**HIGHLINE VILLAGE 4 APARTMENTS
 SITE PLAN
 LOT 1, BLOCK 1 HIGHLINE VILLAGE 4,
 CITY OF AURORA, COUNTY OF ADAMS, STATE OF COLORADO
 3.726 ACRES**

2nd Review
 Aurora Water
 Jennifer Wynn
 jwynn@auroragov.org

**Highline Village 4
 Apartments
 Site Plan**

1 SITE PLAN
 SCALE: 1"=20'

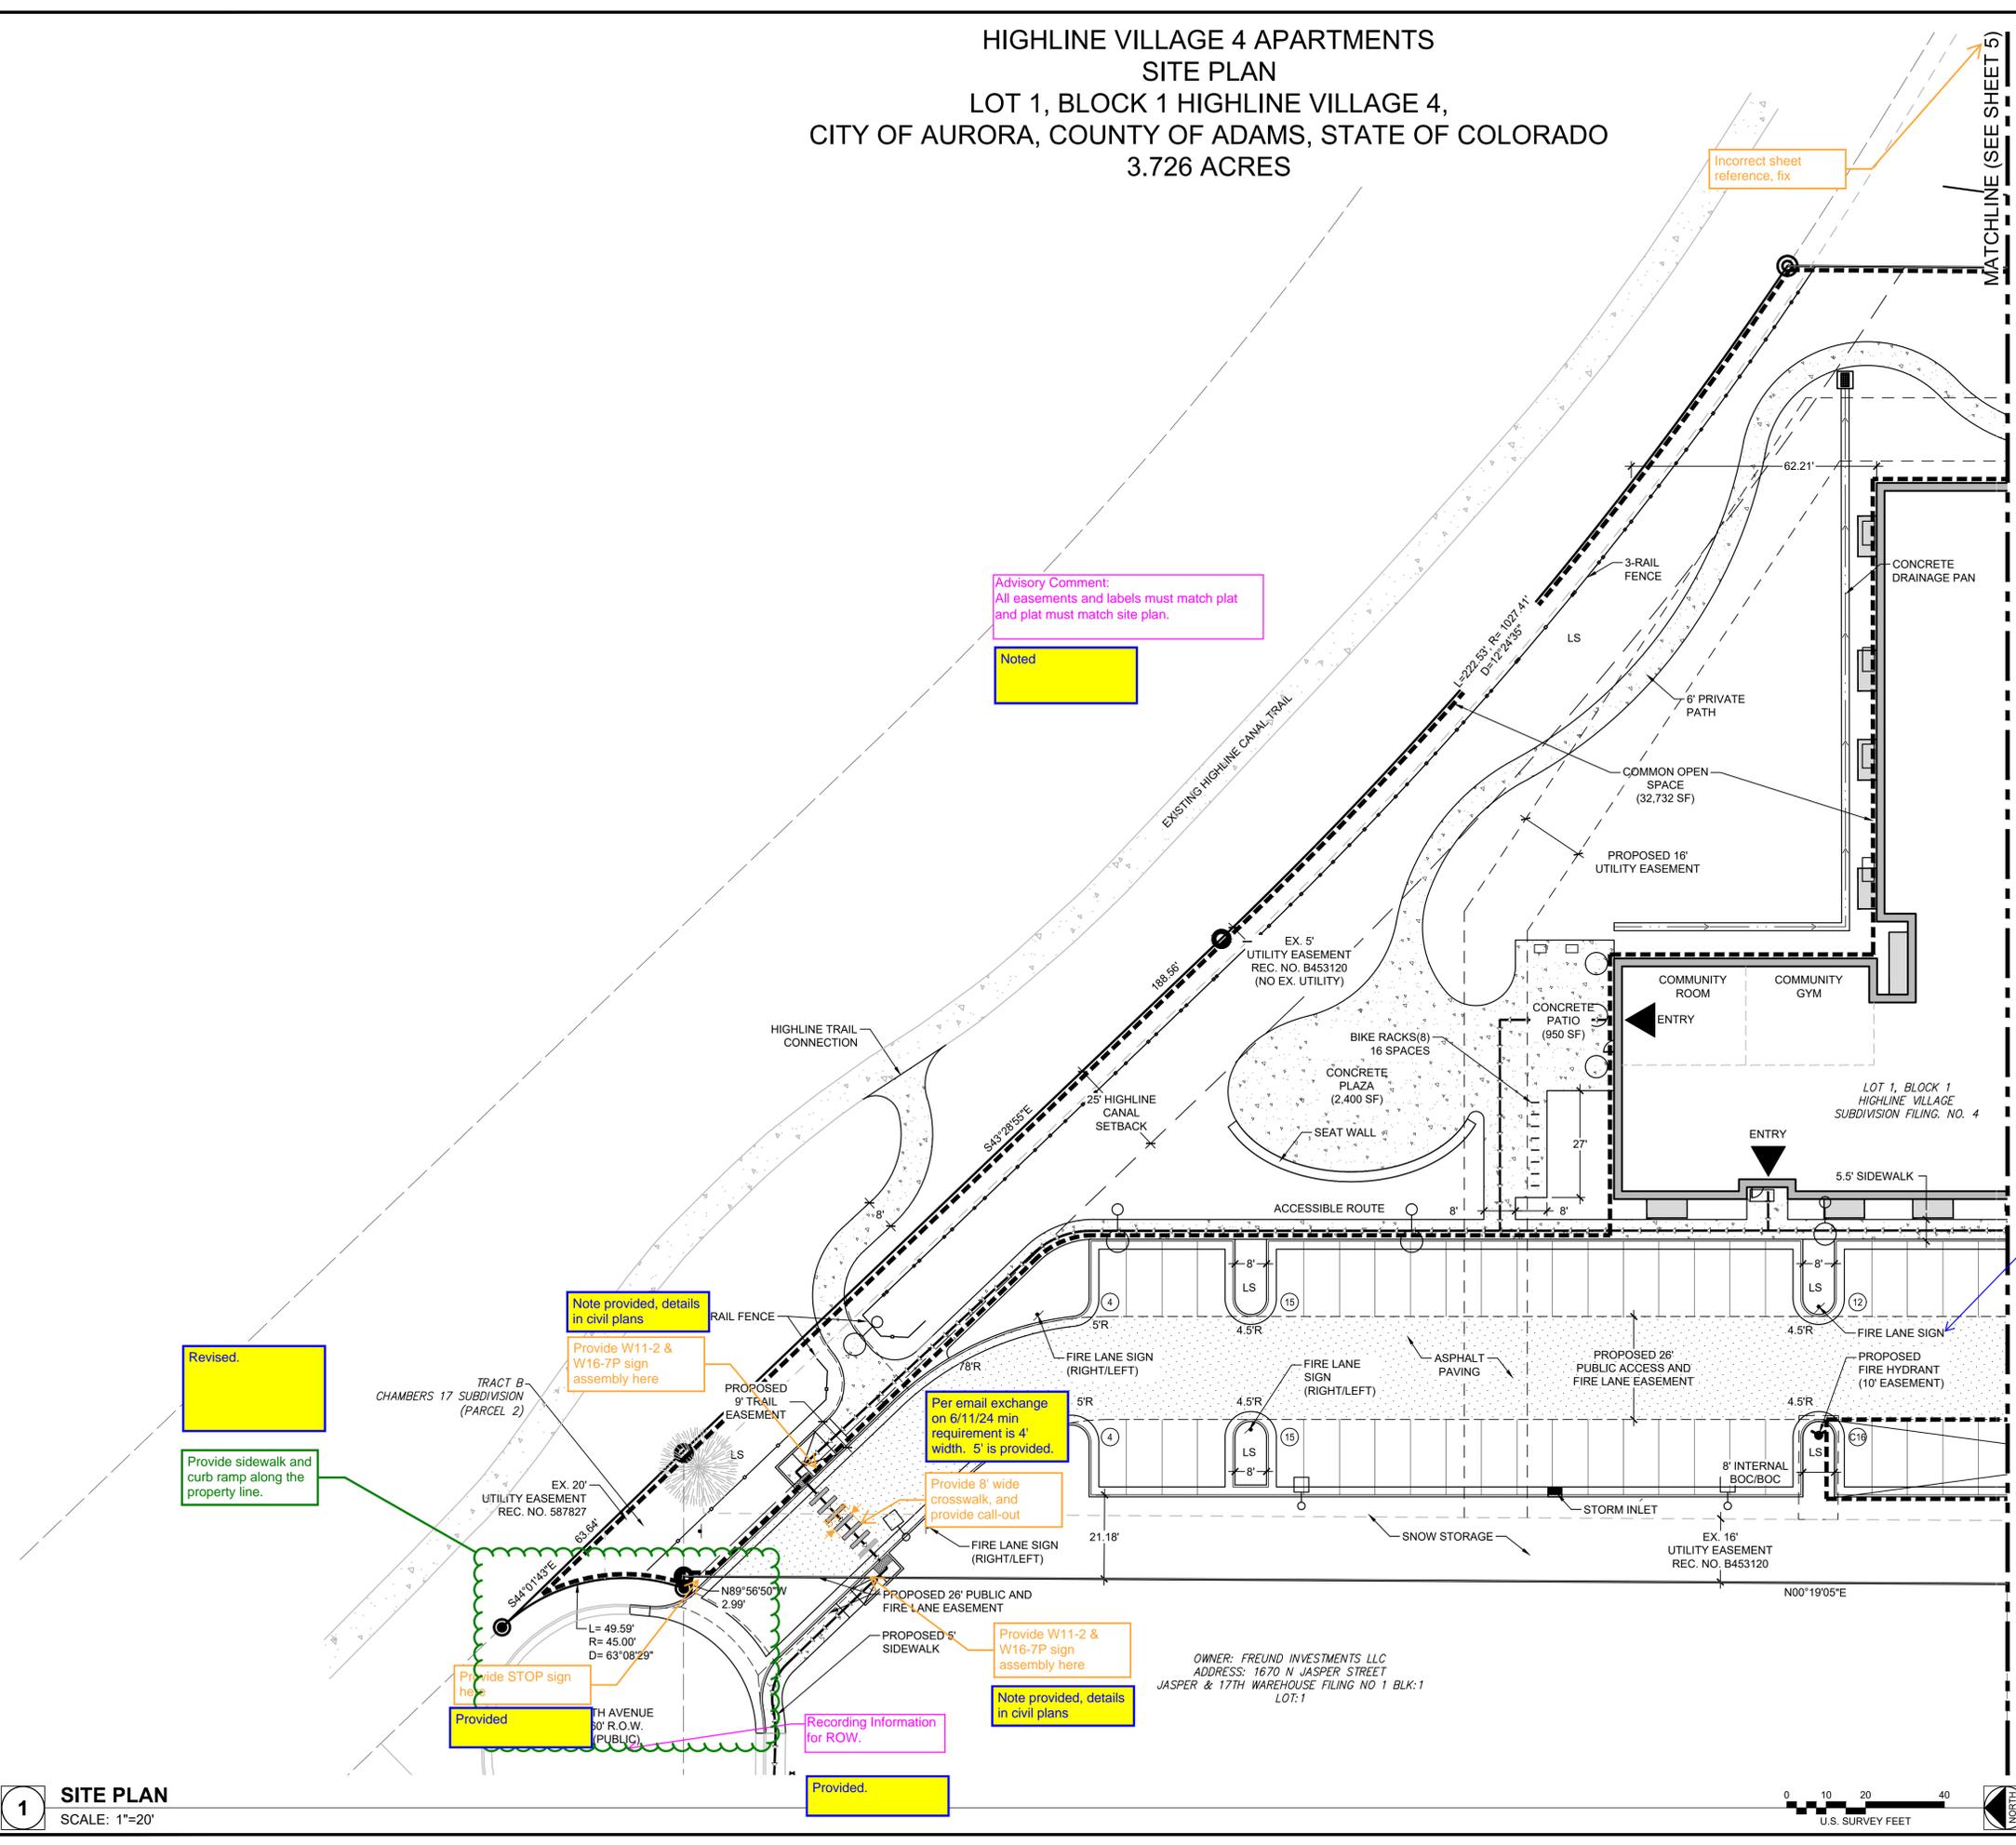
Advisory Comment:
 All easements and labels must match plat and plat must match site plan.

Incorrect sheet reference, fix

Provide sidewalk and curb ramp along the property line.

Provide W11-2 & W16-7P sign assembly here

Provide 8' wide crosswalk, and provide call-out

Provide STOP sign here
 Provided

Recording Information for ROW.
 Provided.

Identify arrow direction on fire lane sign.

Noted

Revised.

Note provided, details in civil plans

Per email exchange on 6/11/24 min requirement is 4' width. 5' is provided.

Provided

1 SITE PLAN
 SCALE: 1"=20'

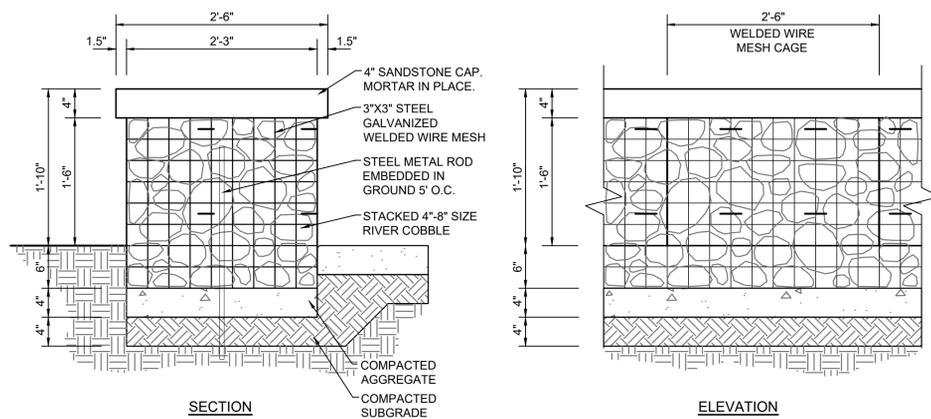
Updated
 Provide sheet reference for match line

Updated
 Accessible route must connect to building entrance. Anywhere accessible goes into a drive aisle there must be a crosswalk.

Revised
 Provide a call-out for 4" WHITE PARKING STALL MARKING (TYP)

Revised
 Provide call-out for handicapped area parking

Extend accessible route to the furthest point in the access aisles.

Provide 8' wide crosswalk

Repeat Comment:
 Provide street name, ROW width, mentioned private or public, provide street classification.

Label Street Name, ROW Width, & Recording Information for ROW.

Provide sidewalk and curb ramp along the property line/ along the development limits.

Identify this sign. Add fire lane sign here. Provided

26' internal radius is provided within the drive. See turning radii in plan. Changing curb radius is not necessary and creates issues with other grading requirements for driveway slopes

Revised however if this is already striped as accessible it already covered and showing an additional graphic to say it twice is excessive.

Provided

Revised

Revised

Updated

Fire lane sign relocated adjacent to hydrant

1 GRADING PLAN 1 OF 2
 SCALE: 1"=20'

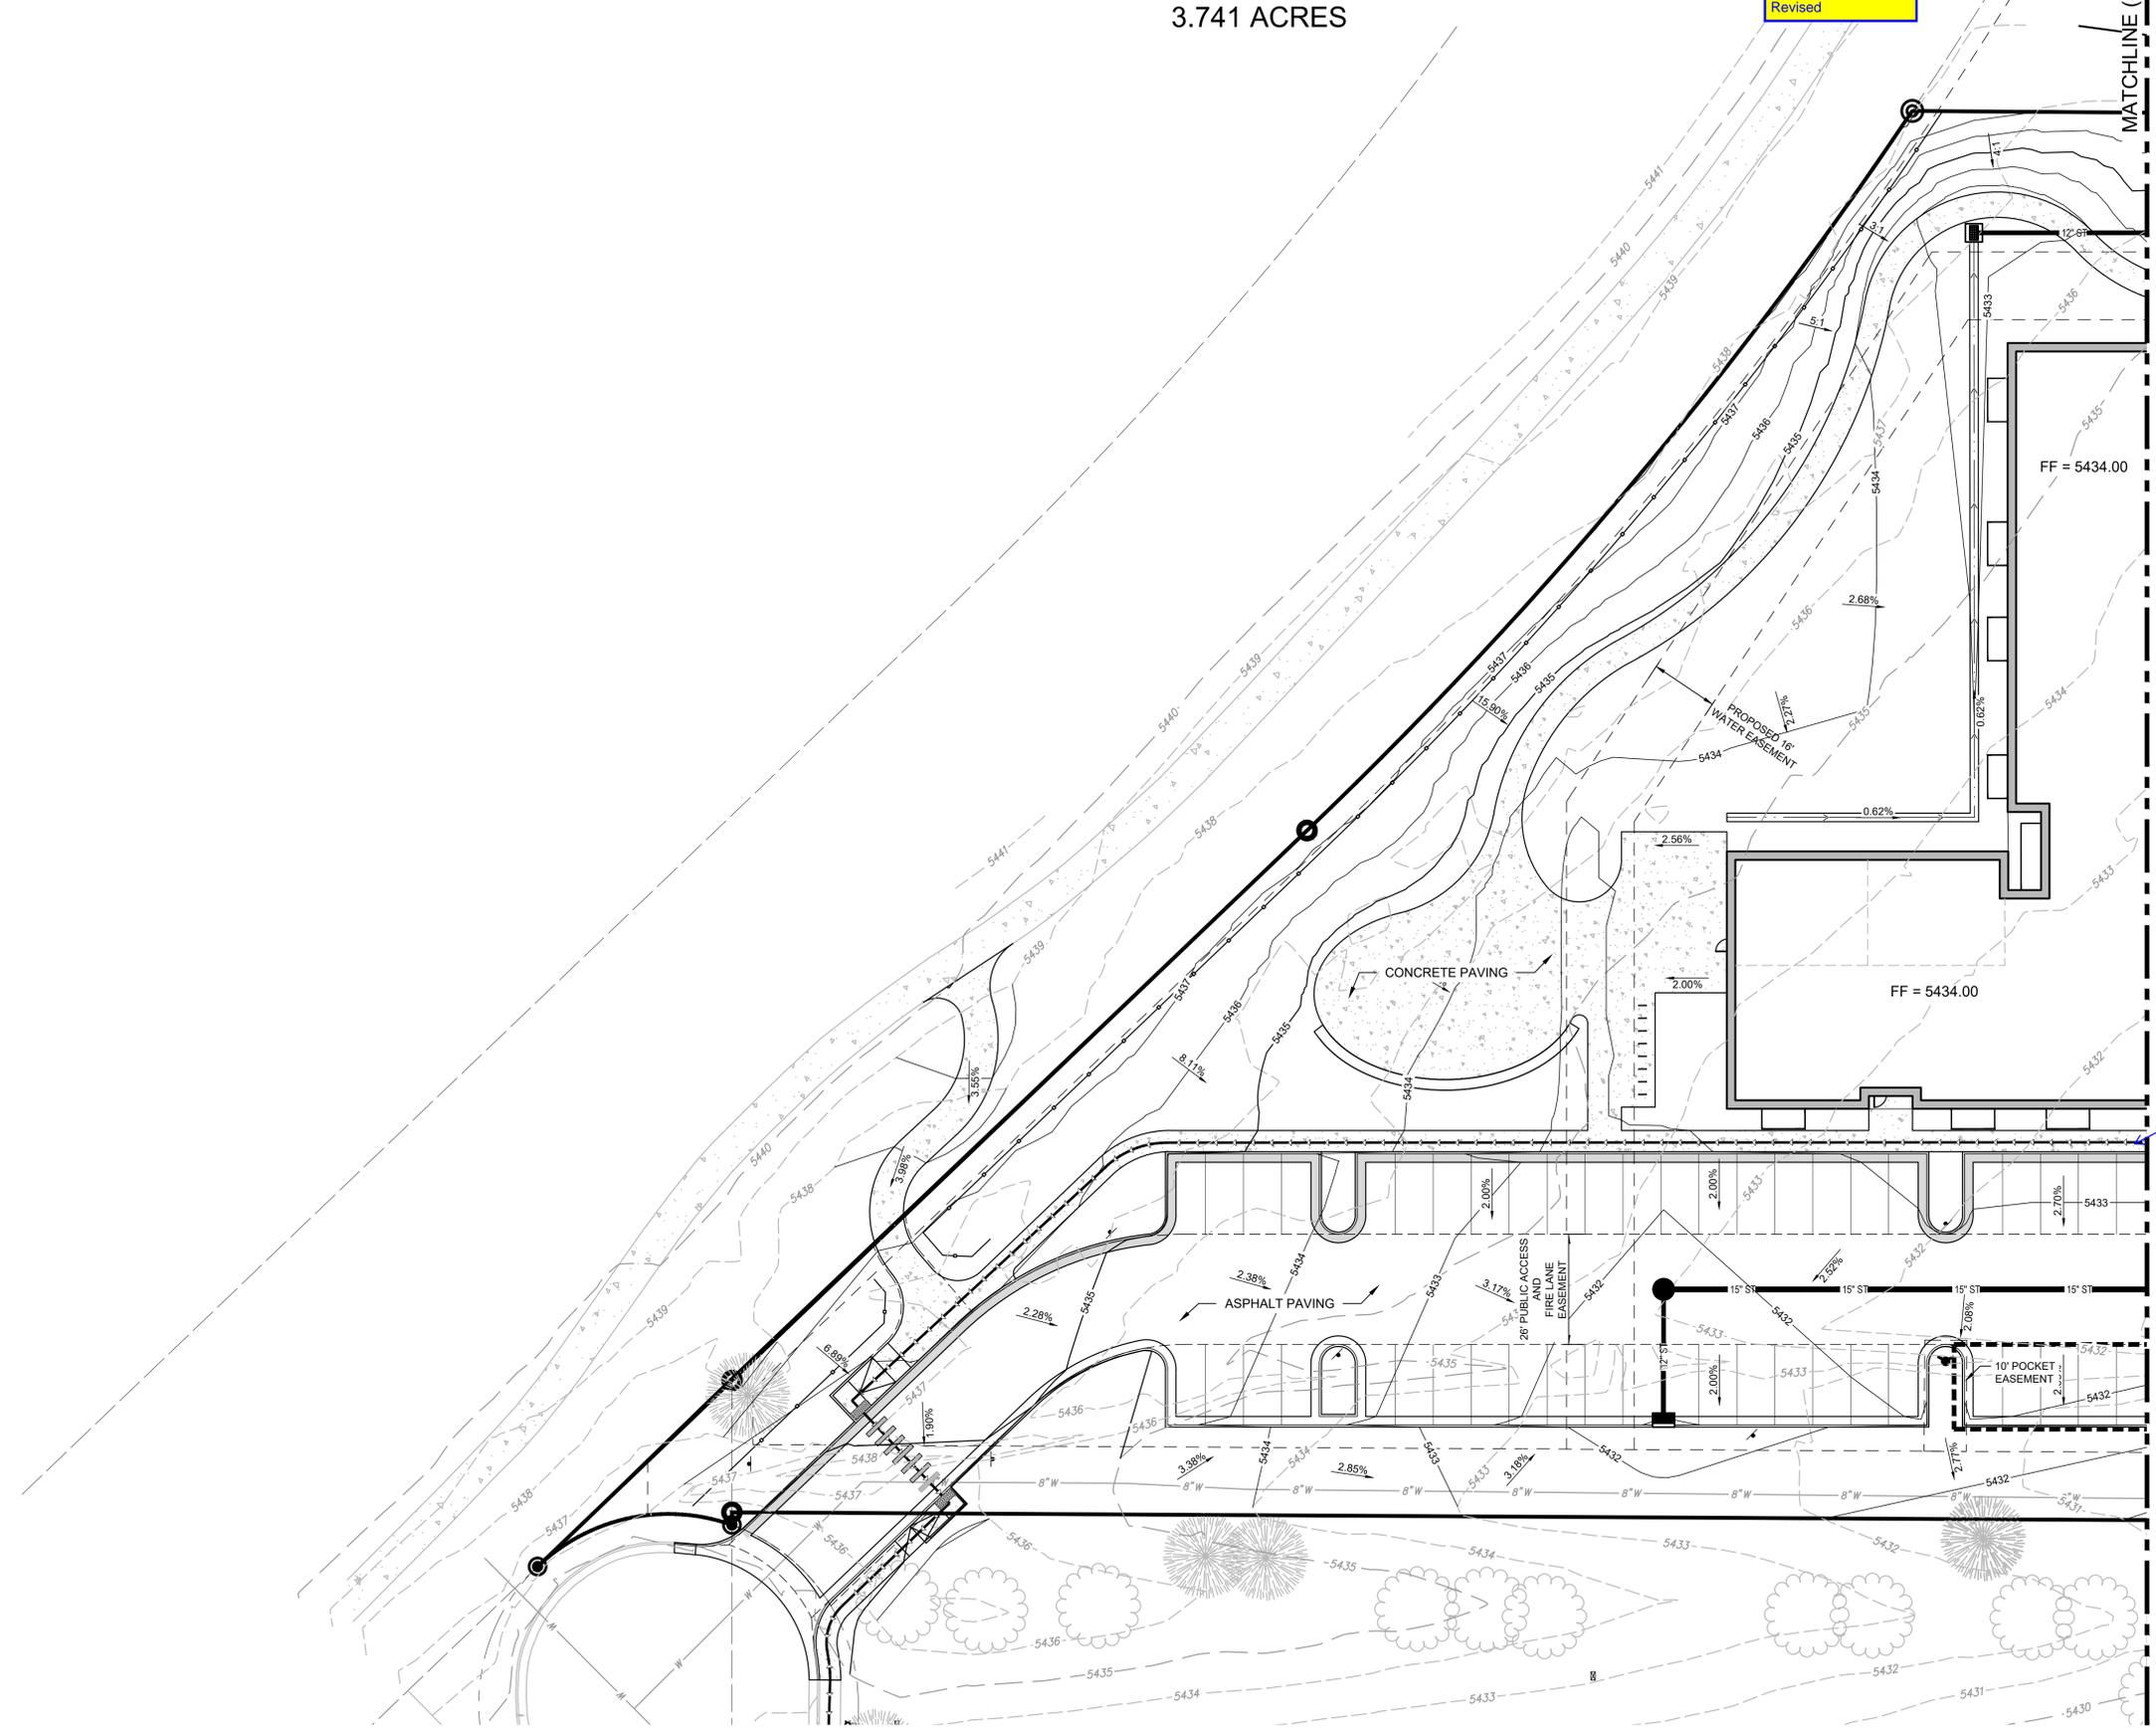
This is SHEET 5,
 provide correct
 reference

Provide grade percentages in accessible routes on all grading sheets.

Revised

Provided
